TiGa Barrytown Mine Consent APPLICATION - REQUEST FOR INFORMATION - GEOTECHNICAL

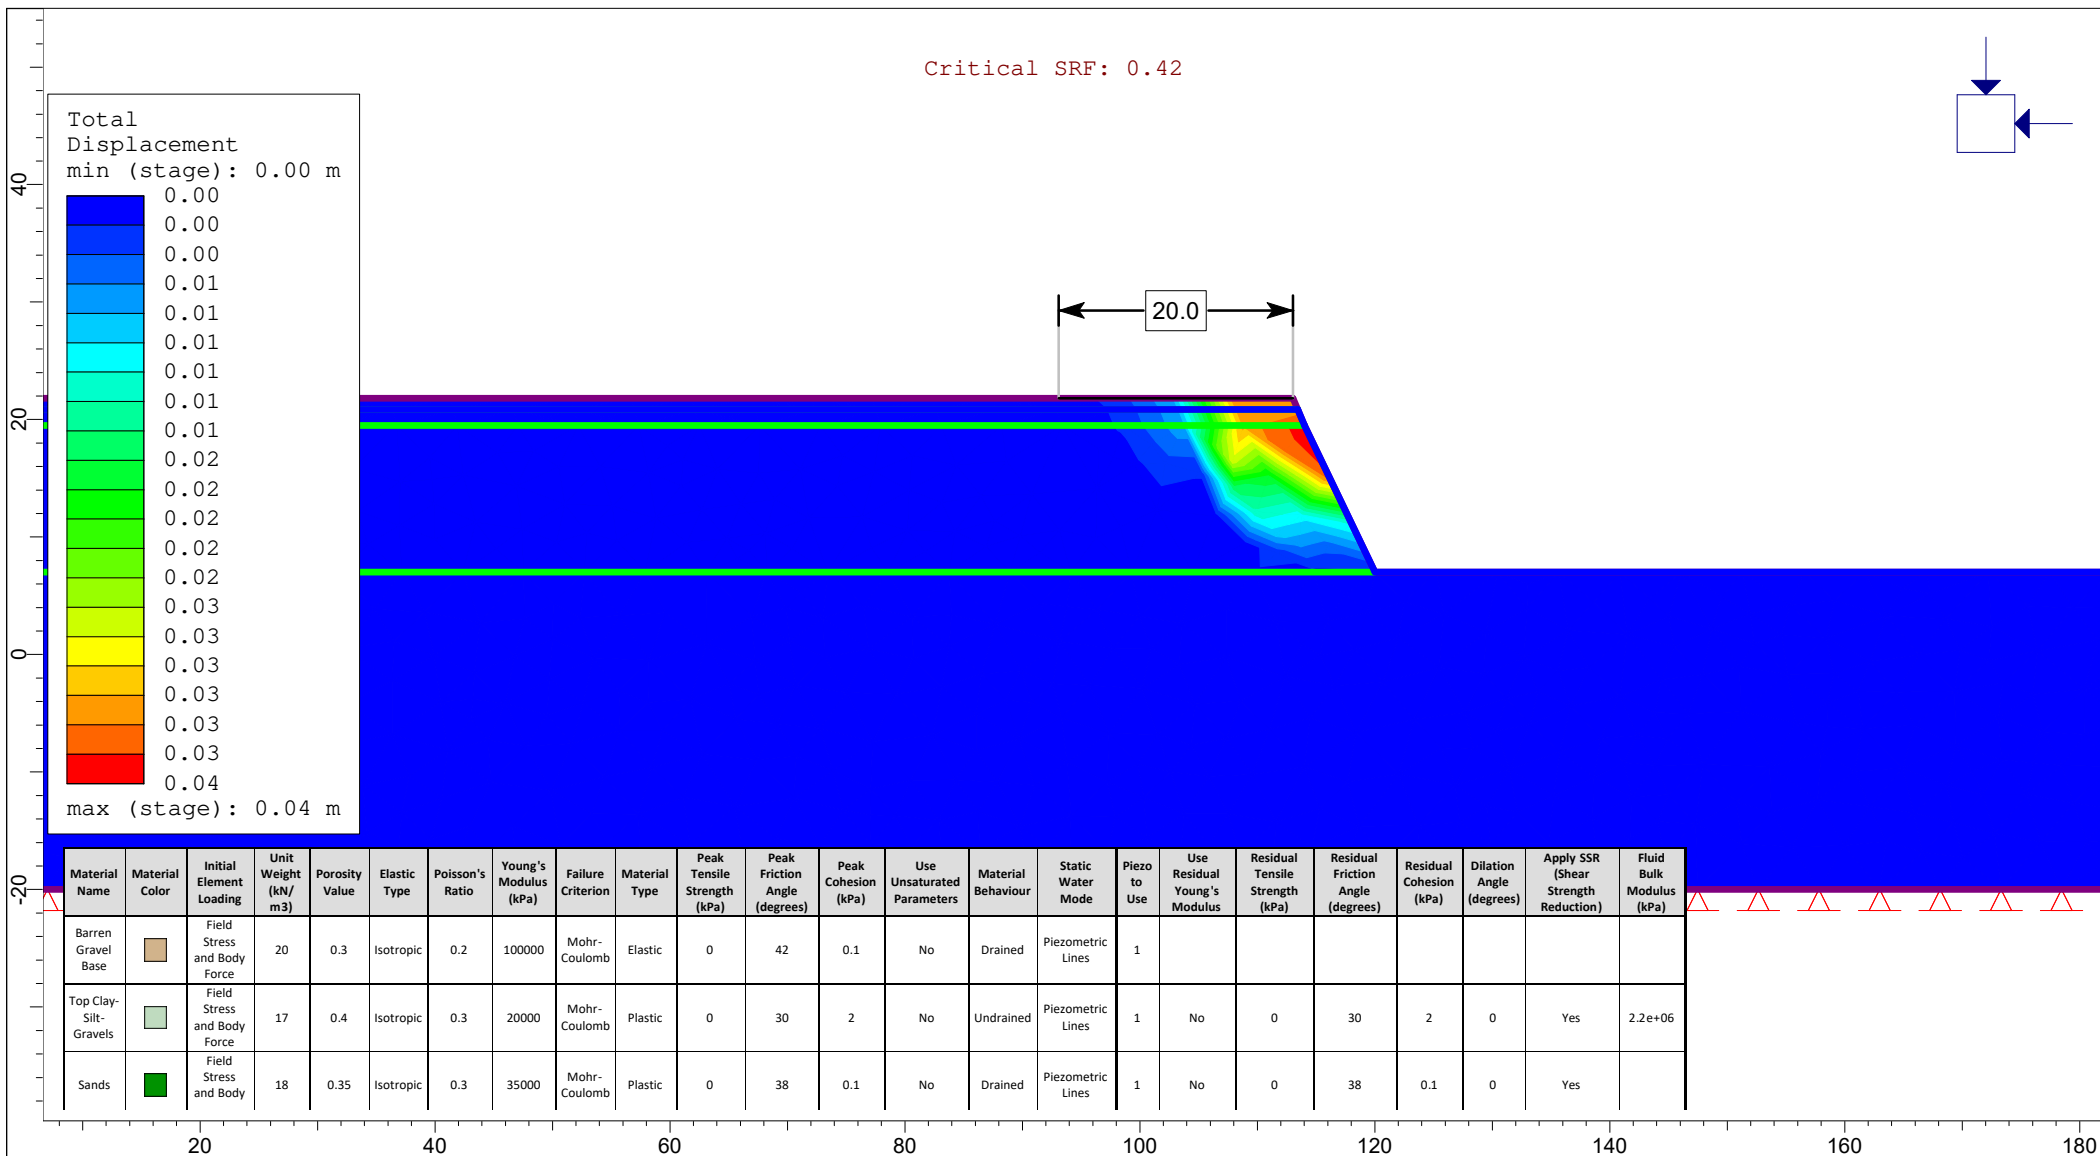
38.	Appendix B	The slope stability models documented in Appendix B indicate mineral sand extraction will extend to the top of the basal gravel layer. The basal gravel layer constitutes a more permeable aquifer that the overlying mineral sands, according to the Hydrology report. Additionally, it is not clear from either the Hydrology report or the Geotechnical report whether mineral sand extraction is to extend to the top of the basal gravel layer. Please confirm the slope stability models correctly represent the layout of the pit walls according to the current mine plan. If the model layout does not provide an appropriate conceptual representation of a pit wall under the current mine plan, please adjust the models to more accurately represent the of the pit shell layout with respect to the geological units simulated.	The slope stability models correctly represent the layout of the pit walls and sand extraction is extended to the top of the base layer in accordance with drawings from Palaris (as seen below):
